ADDENDUM NO. 01

**TO
SPECIFICATIONS AND CONTRACT DOCUMENTS
FOR
INVITATION TO BID
BIMT/TMT HANJUNG CRANE CATENARY TROLLEY RAIL PARTS
JPA CONTRACT NO.: EQ-2045B**

BIMT/TMT HANJUNG CRANE CATENARY TROLLEY RAIL PARTS JPA CONTRACT NO.: EQ-2045B

RESPONSE TO QUESTION(S)

Attachment No. 2 - *Picture of Drawing 3RMQ9-47-124*

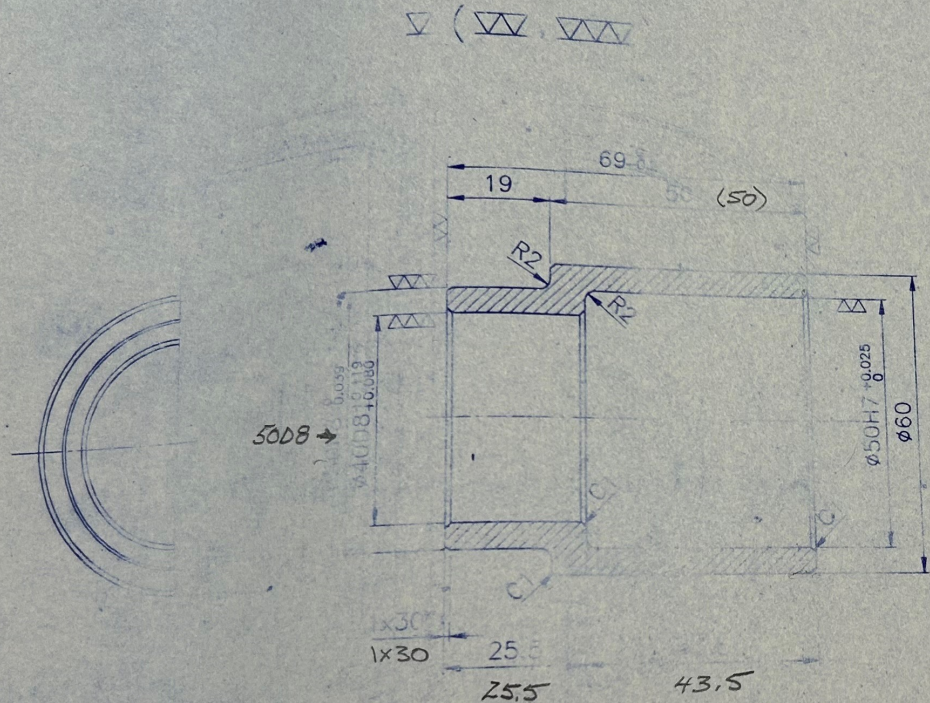
5. Drawing 3RMQ9-47-124 is not readable please supply a clear drawing

ANSWER: See Addendum Attachment No. 2 for a picture of drawing 3RMQ9-47-124. A physical part will be provided to the Awarded contractor for acquiring exact measurements.
